**Licence Number** L9221/2019/1

**Licence Holder** Fortescue Metals Group

**Premises** Eliwana Iron Ore Mine

**Date of Report** 21/05/2020

**Figure 2: As constructed layout of Eliwana WWTP**

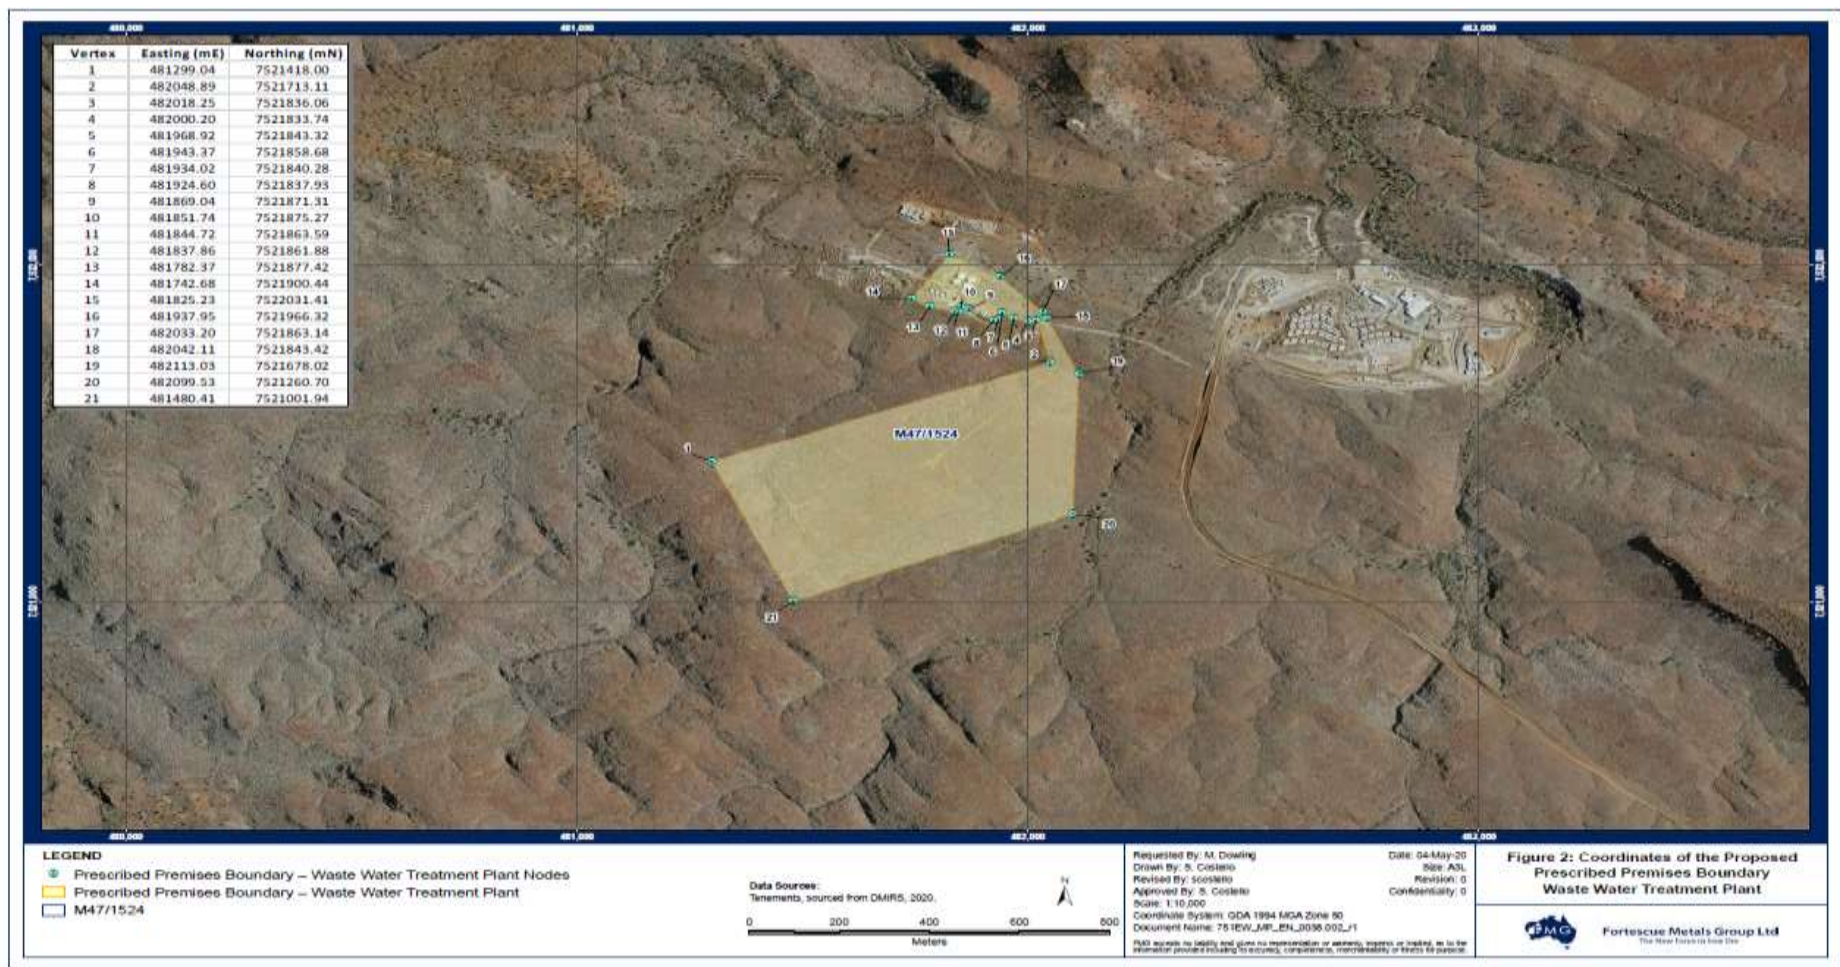
Report section / Condition	Summary of Licence Holder comment	DWER response
		premises boundary map submitted for category 54.
As constructed layout map for Eliwana WWTP	<p>This figure has been amended as requested and is attached. Note, the larger PPB has been replaced by the smaller PPB from the works approval as per a previous request.</p> <p>Fortescue has not committed to any surface or groundwater monitoring in this application and it is not a condition of the works approval for the WWTP to install a monitoring location. However, a monitoring site for Part IV purposes is located downstream of the WWTP and accommodation camp and is shown in the amended figure.</p>	<p>Noted.</p> <p>The Licence does not require surface water or groundwater monitoring. However, monitoring of treated wastewater discharged at the sprayfield is required in accordance with Condition 5 of the Licence. The monitoring location is specified in Condition 5 Table 3 of the Licence.</p>
